Access Compliance Report Public Rights-of-Way (Curb Ramps)

Main Street: CANDLEWIND_CT Cross Street: CELESTINE_CIR Location: NE

ADA ID: RPAT211029120554 Ramp Type: Type 4 - Parallel Initial Pass/Fail: Pass Overall Compliance: No Severity Score: 15

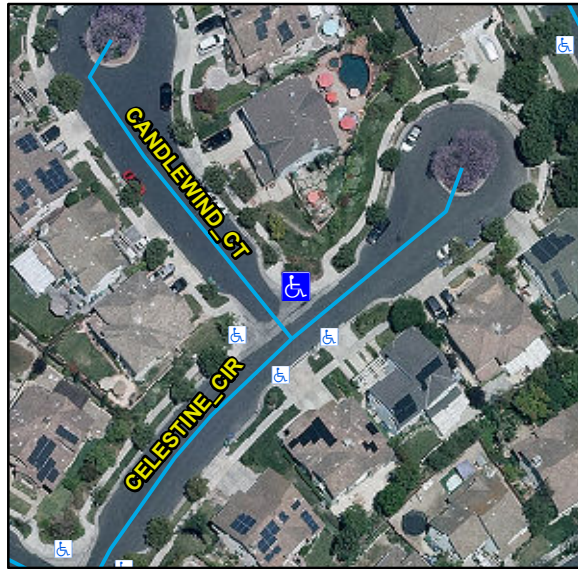
Crossing 1 Slope (%)	0.4		Crossing 2 Slope (%)	1.9
	Crossing 1 Cross Slope (%)	2.3		Crossing 2 Cross Slope (%)	0.8
Yes	Gutter Ponding	No	No	Curb Slope	10
Yes	Gutter Lip Height (in)	0		Road Run Slope (%)	3.2
No	Gutter Run Slope (%)	7.4		Road Cross Slope (%)	3.3
Yes	Gutter Cross Slope (%)	1.3	No	Perpendicular Joint Present	No
Yes	Overall Surface Condition	Acceptable			
	Cross Gutter Present?	Yes		Spandrel Present?	Yes
	Replace Cross Gutter?	No		Replace Spandrel?	No

Remove & Replace Curb Ramp With Two New Directional Ramps or Equivalent. Remove & Replace Gutter.
